# Intel<sup>®</sup> Pentium<sup>®</sup> III Processor Specification Update

Release Date: October 2001

Order Number: 244453-034

The Pentium<sup>®</sup> III processor may contain design defects or errors known as errata which may cause the product to deviate from published specifications. Current characterized errata are documented in this Specification Update.

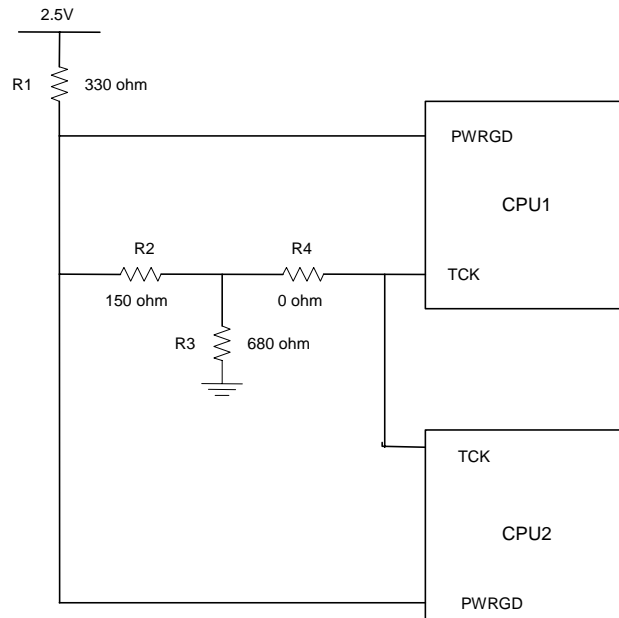
**Problem:** The internal control register bit responsible for operation of the Thermtrip circuit functionality may power up in a non-initialized state. As a result, THERMTRIP# may be incorrectly asserted during de-assertion of RESET# at nominal operating temperatures. When THERMTRIP# is asserted as a result of this erratum, the processor may shut down internally and stop execution but in few cases continue to execute.

**Implication:** This issue can lead to intermittent system power-on boot failures. The occurrence and repeatability of failures is system dependent, however all systems and processors are susceptible to failure. In addition, the processor may fail to stop execution during the event of a valid THERMTRIP# assertion resulting in the potential for permanent processor damage.

**Workaround:** To prevent the risk of power-on boot failures or catastrophic thermal failures, a platform workaround is required. The system must provide a rising edge on the TCK signal during the power-on sequence that meets all of the following requirements:

- Rising edge occurs after Vcc\_core is valid and stable
- Rising edge occurs before or at the de-assertion of RESET#
- Rising edge occurs after all Vref input signals are at valid voltage levels
- TCK input meets the Vih min and max spec as mentioned in EMTS
